SUBJECT: CHATSWORTH PARK SOUTH – OUTDOOR PARK IMPROVEMENTS (PRJ21885) PROJECT – COMMITMENT OF PARK FEES – CATEGORICALLY EXEMPT FROM THE PROVISIONS OF THE CALIFORNIA ENVIRONMENTAL QUALITY ACT (CEQA) PURSUANT TO ARTICLE 19, SECTION 15301(d) [RESTORATION OR REHABILITATION OF DETERIORATED OR DAMAGED STRUCTURES, FACILITIES, OR MECHANICAL EQUIPMENT TO MEET CURRENT STANDARDS OF PUBLIC HEALTH AND SAFETY] AND SECTION 15330 [MINOR CLEANUP ACTIONS TAKEN TO PREVENT, MINIMIZE, STABILIZE, MITIGATE, OR ELIMINATE THE RELEASE OR THREAT OF RELEASE OF A HAZARDOUS WASTE OR SUBSTANCE WHICH ARE SMALL OR MEDIUM REMOVAL ACTIONS COSTING \$1 MILLION OR LESS] OF CALIFORNIA CEQA GUIDELINES AS WELL AS ARTICLE III, SECTION 1, CLASS 1(4) OF CITY CEQA GUIDELINES

Subject: Five-Year Review
Chatsworth Park South
22360 West Devonshire Street
Chatsworth, California 91311
Assessor's Parcel No. 2723-010-904

5-YEAR REVIEW
CHATSWORTH PARK SOUTH
22360 WEST DEVONSHIRE STREET
CHATSWORTH, CALIFORNIA 91311
ASSESSOR'S PARCEL NUMBER 2723-010-904
APRIL 2025

Figure: 1 – Erosion Areas

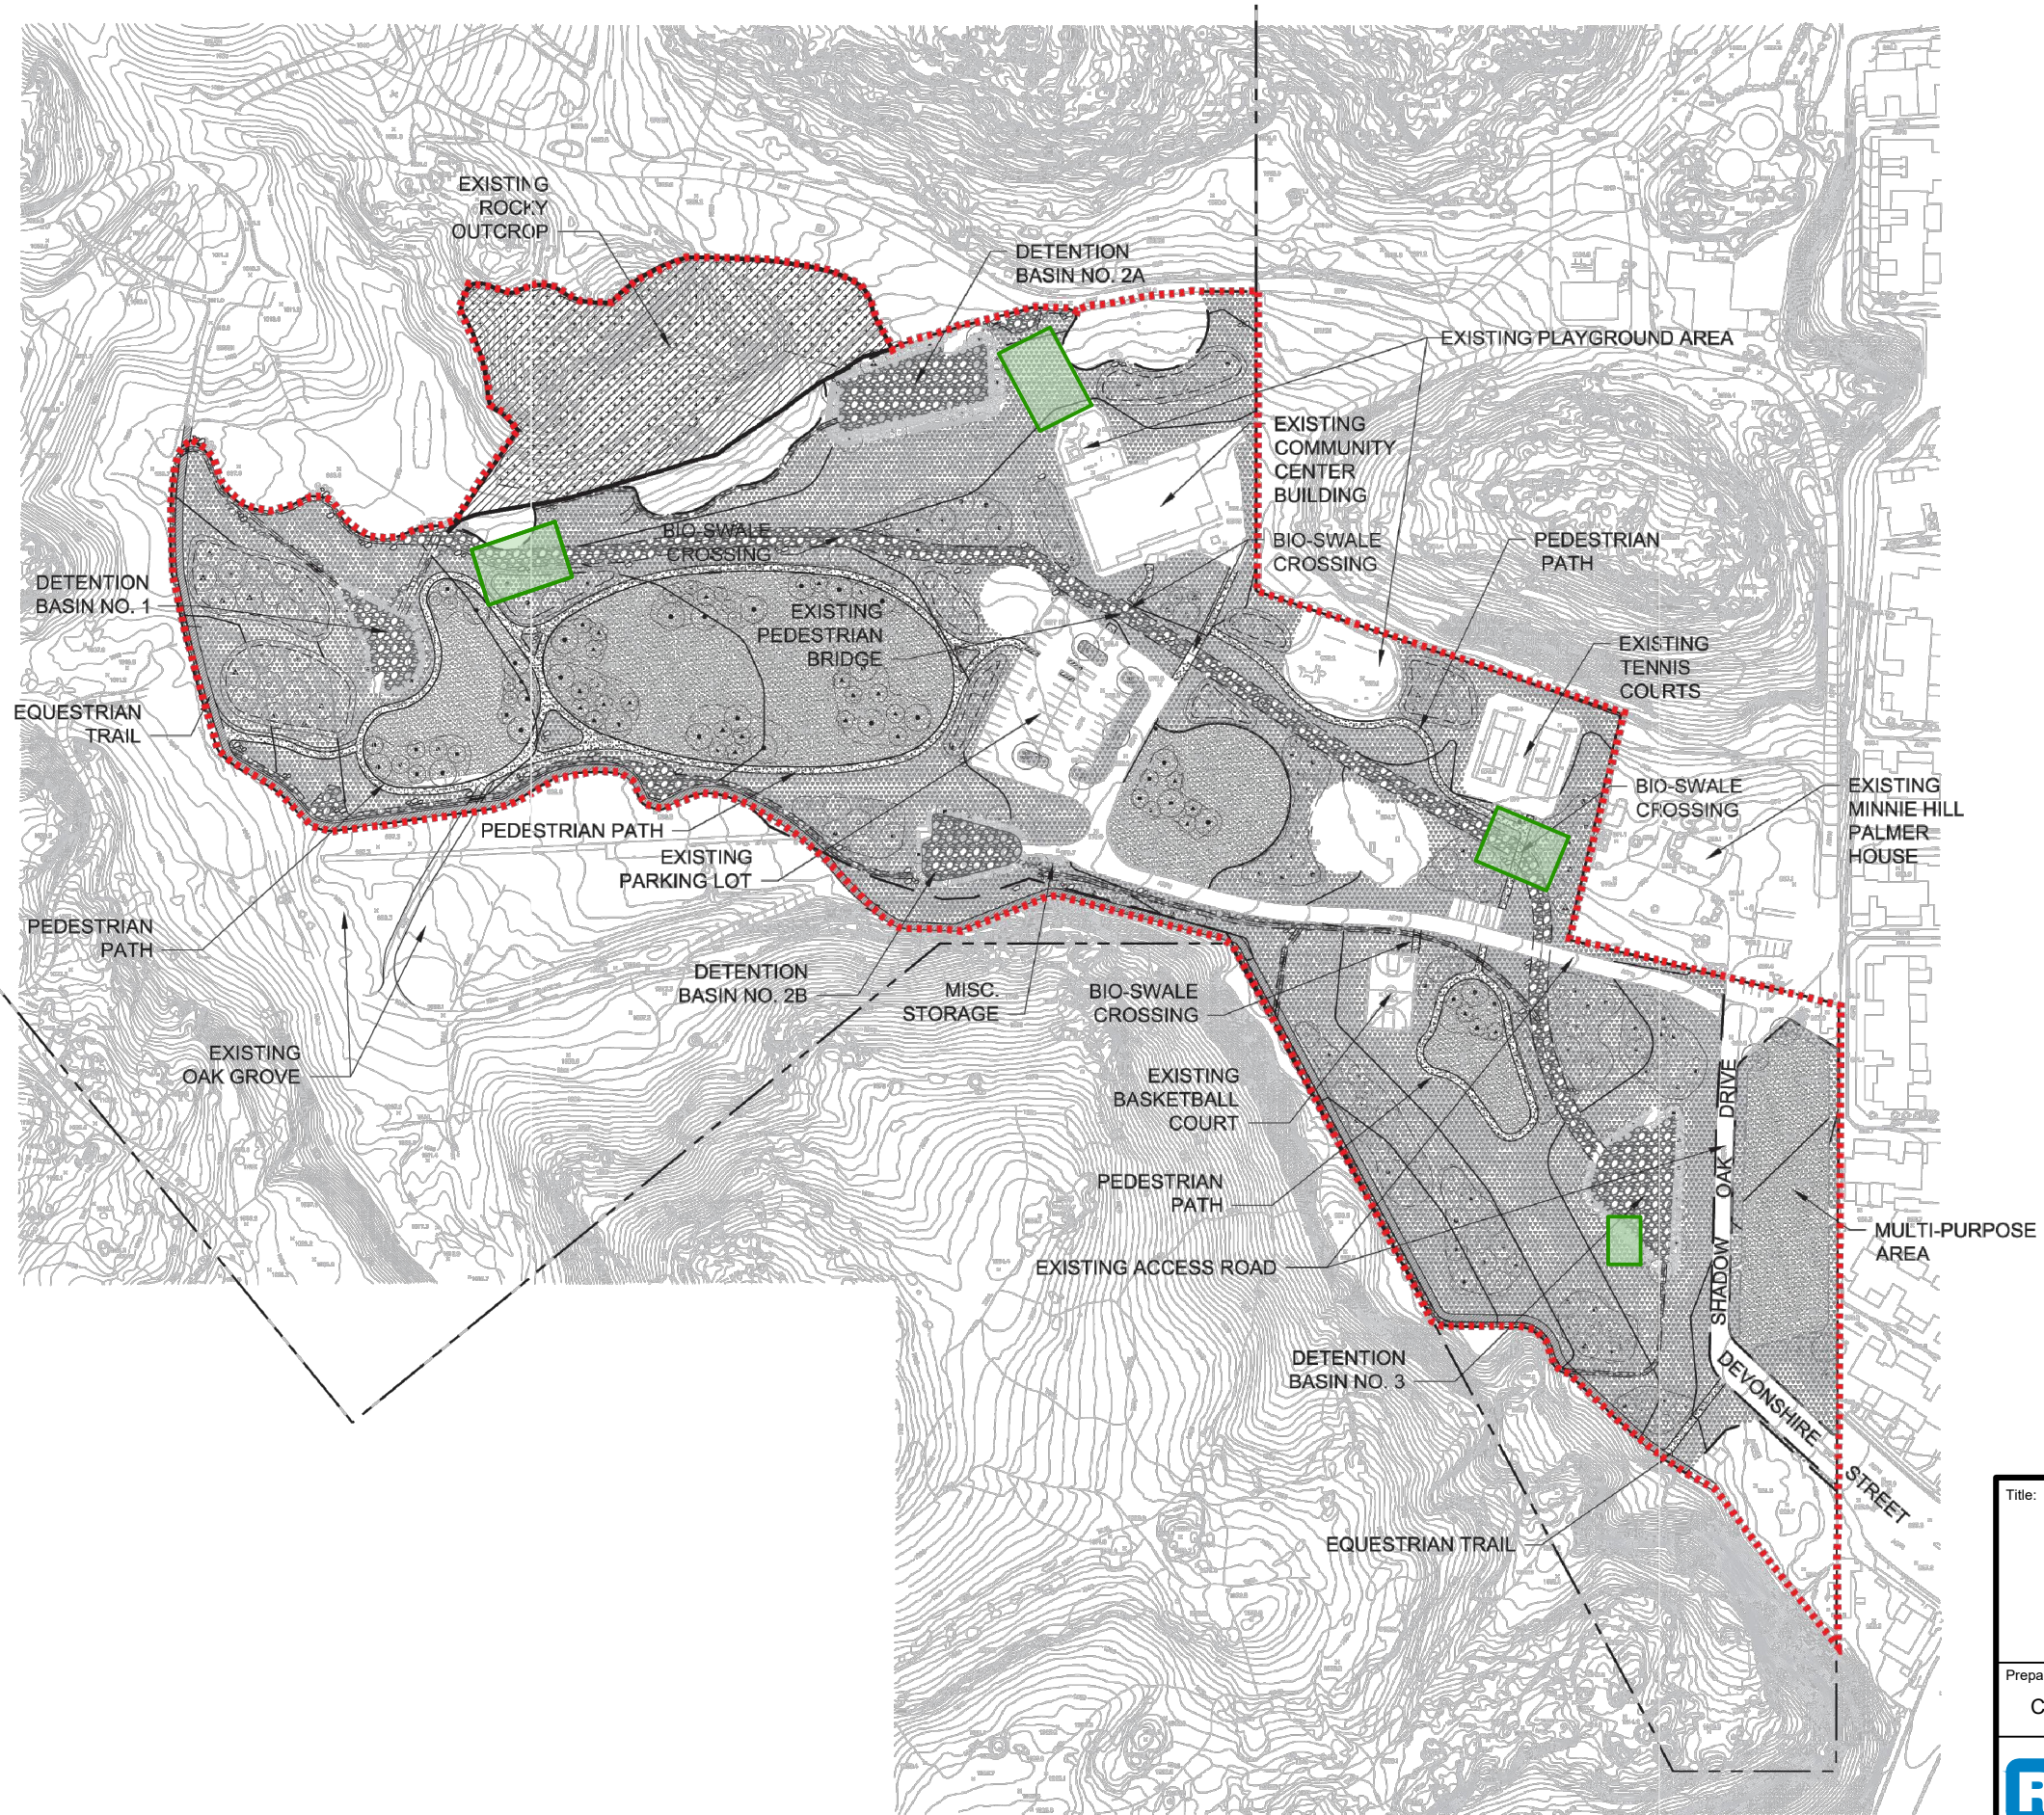
- Four areas of the cap were observed or reported to have eroded to the point of breaching the geo grid exposing the impacted soil beneath (Figure 1). There is inadequate O&M of physical remedial structures (Attachment 2 - Photographs 11 through 15, 20, and 21).

Repairs to the areas of the cap that have eroded beneath the geo grid must be made for the cap to again be protective of human health and the environment. The remaining issues identified in Section 7 should be addressed in a timely manner.

- Immediate repairs are needed in the areas where the cap has been breached below the geo grid:
 - Retain the services of Hazardous Waste Operations and Emergency Response (HAZWOPER)-trained staff/contractor to repair the damage and restore the surface cap to its original condition.
 - Any soil excavated beneath the geo grid as part of the repair must be managed in accordance with the Soil Management Plan (Appendix C of the O&M Plan).
 - Notify the DTSC of the repairs in accordance with Section 4.4.1 of the O&M Plan.

20. Significant swale erosion area near tennis courts showing repair and best management practices (BMP)

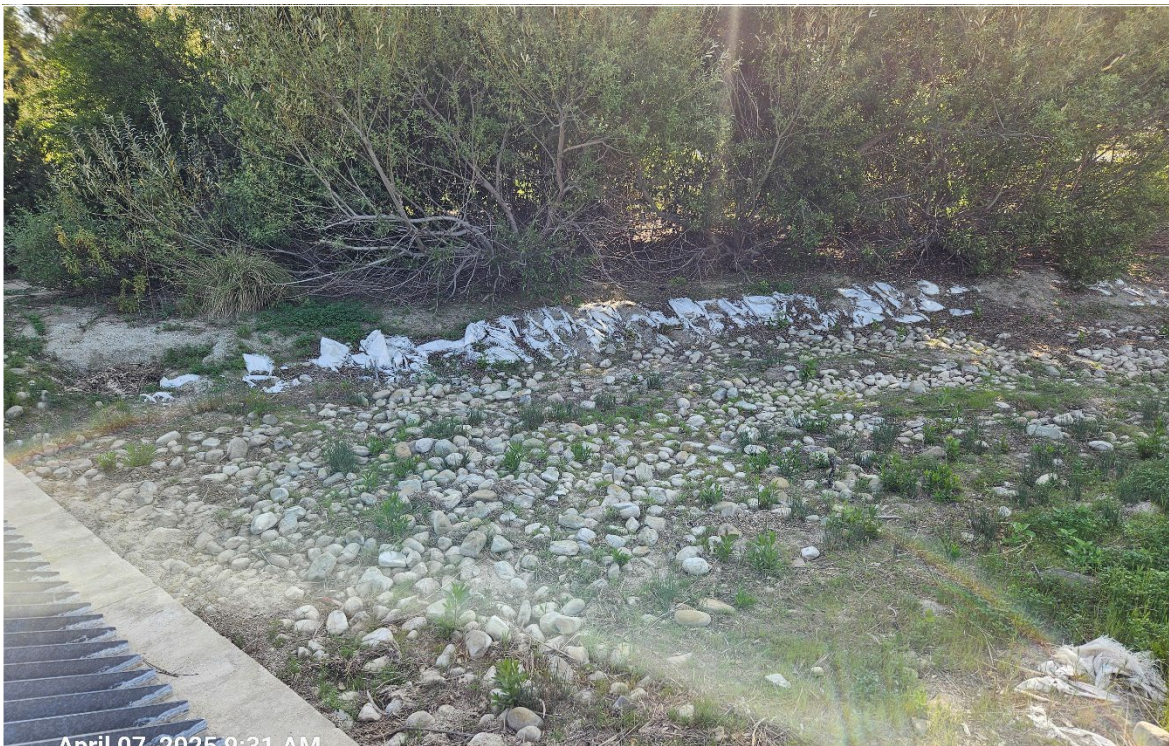
- The detention basins have become overgrown to the point that inspection was difficult (Attachment 2 - Photographs 16 through 18).
- There is evidence of burrowing animals throughout the cap (Attachment 2 - Photograph 19).

23. Foot path visible in fenced area of southwest side of Site

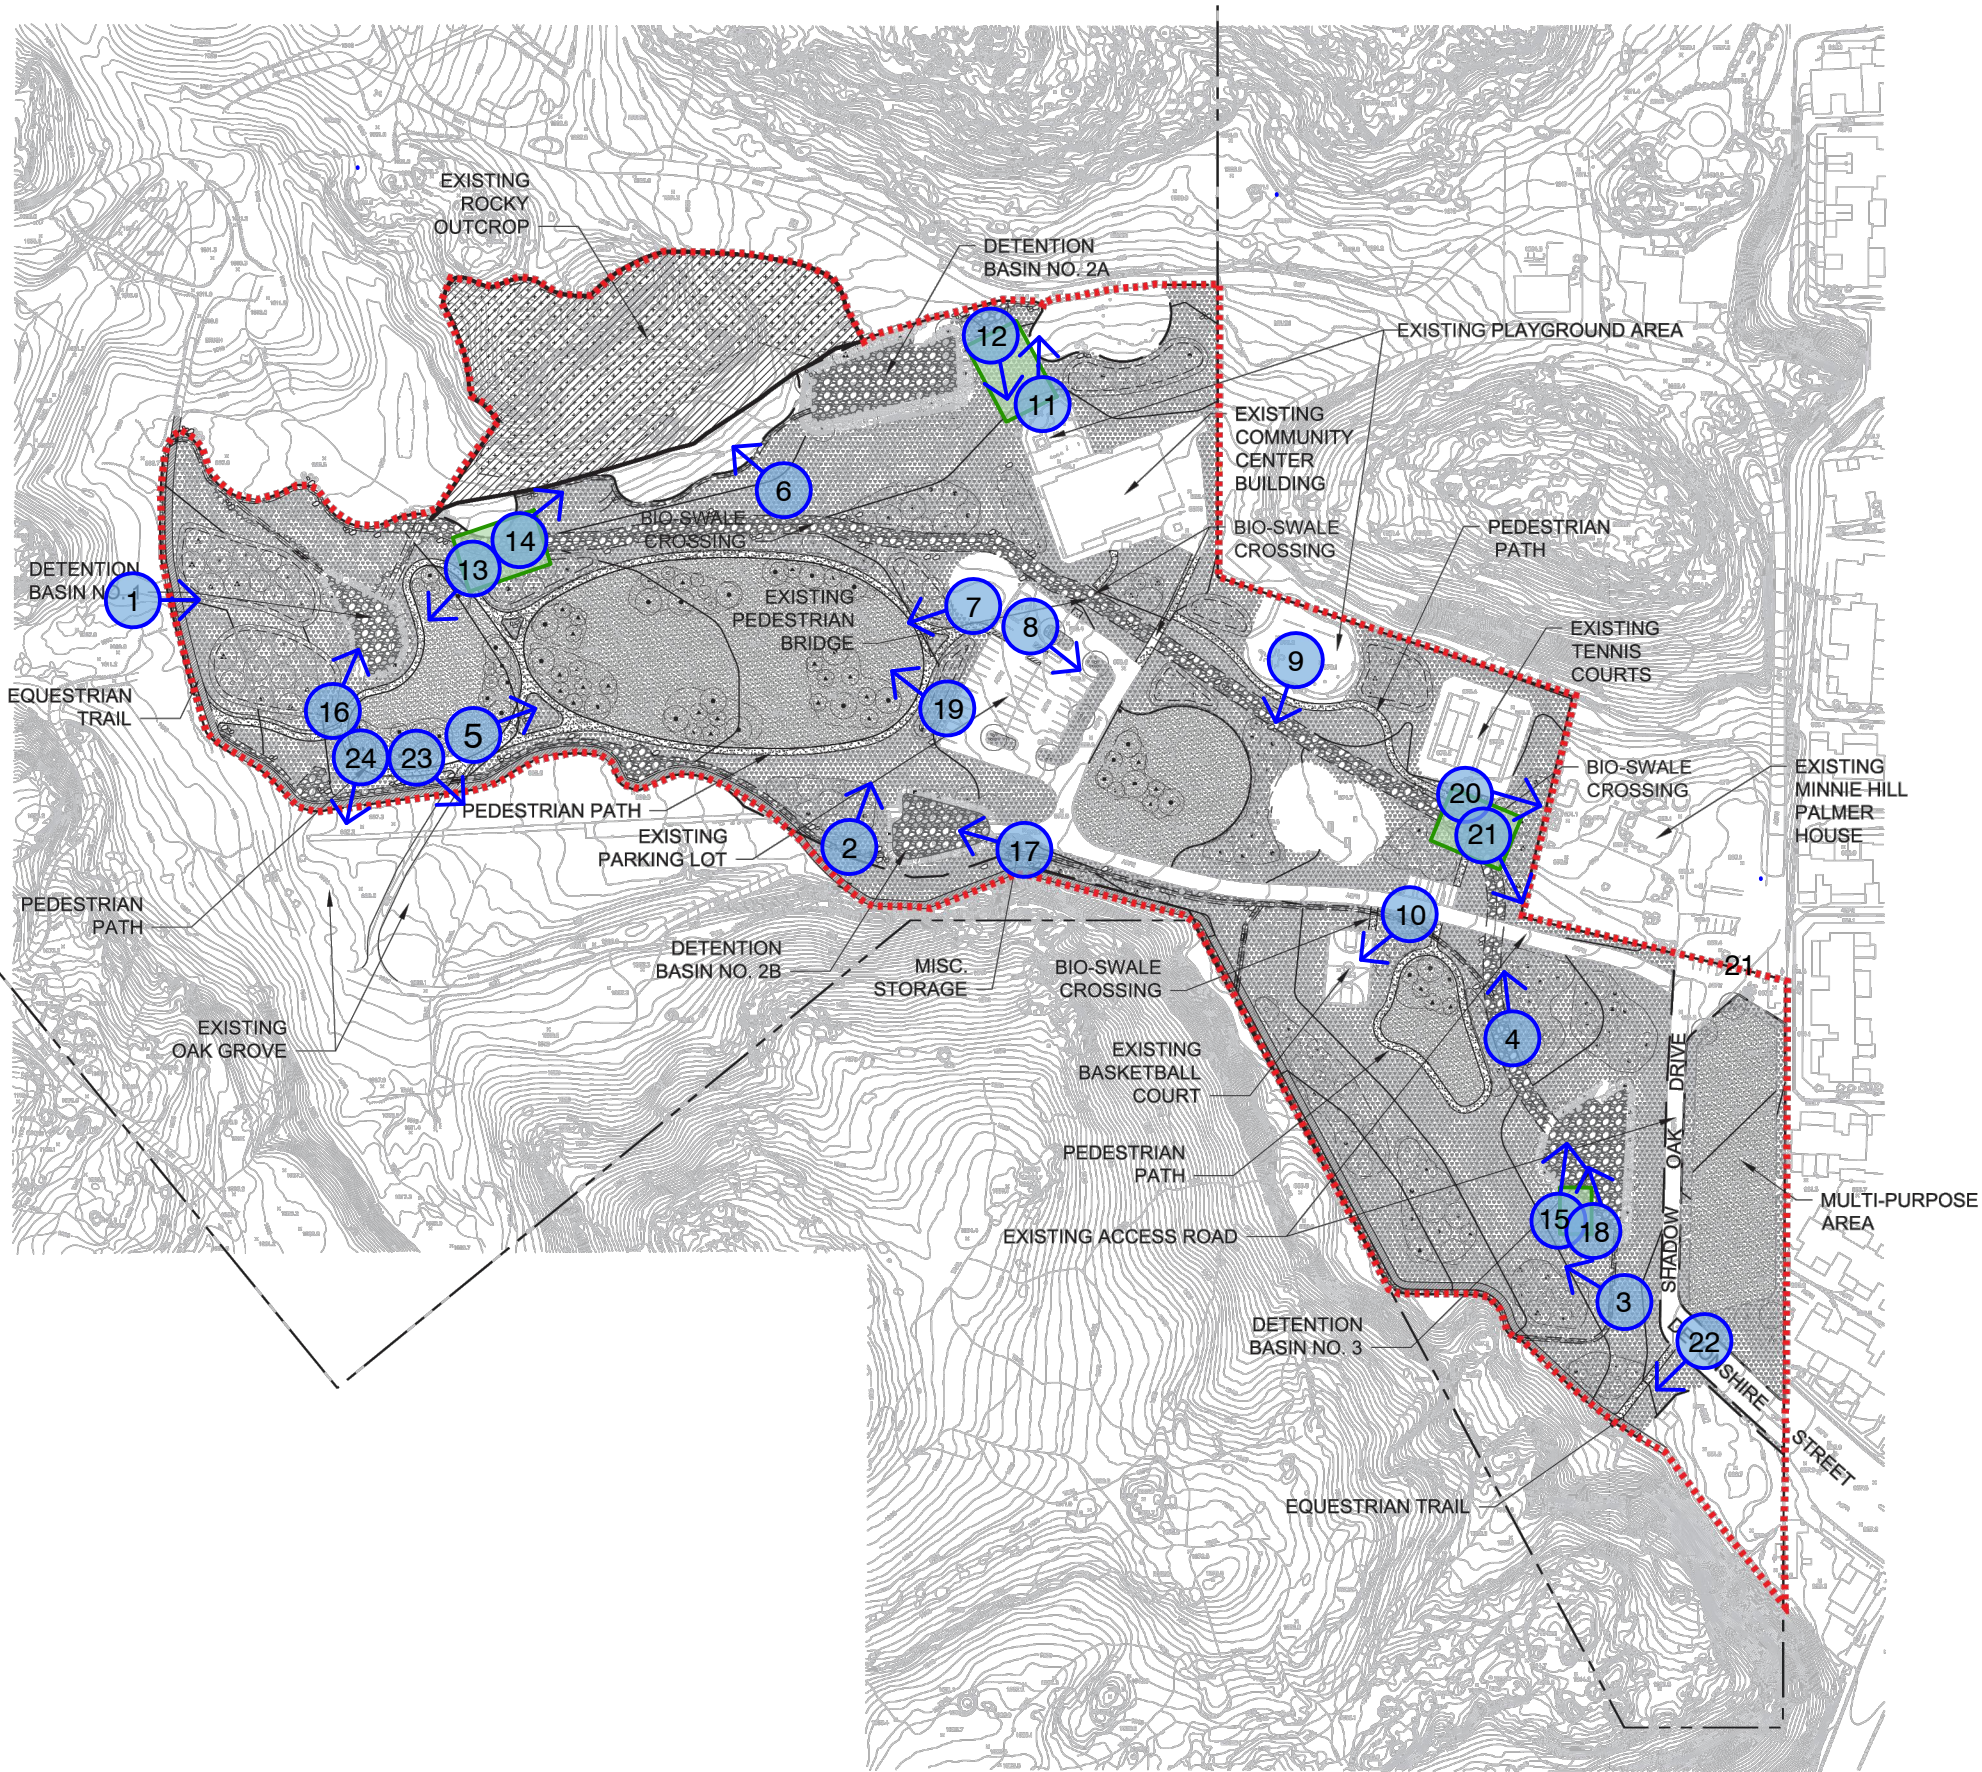
- There is evidence of regular foot traffic through some of the fenced areas. Mr. Cerezo indicated that the gate locks are regularly broken, and people access the areas to use like a dog park (Attachment 2 - Photographs 23 and 24). Current barriers/warnings are not adequate to restrict access.

- Add signage to the fenced areas where regular foot traffic is occurring to discourage entry.
- Update the O&M Plan and provide training to the site maintenance team regarding the requirements of the O&M Plan, including when to notify of issues and when HAZWOPER-trained staff/contractor repairs are necessary.
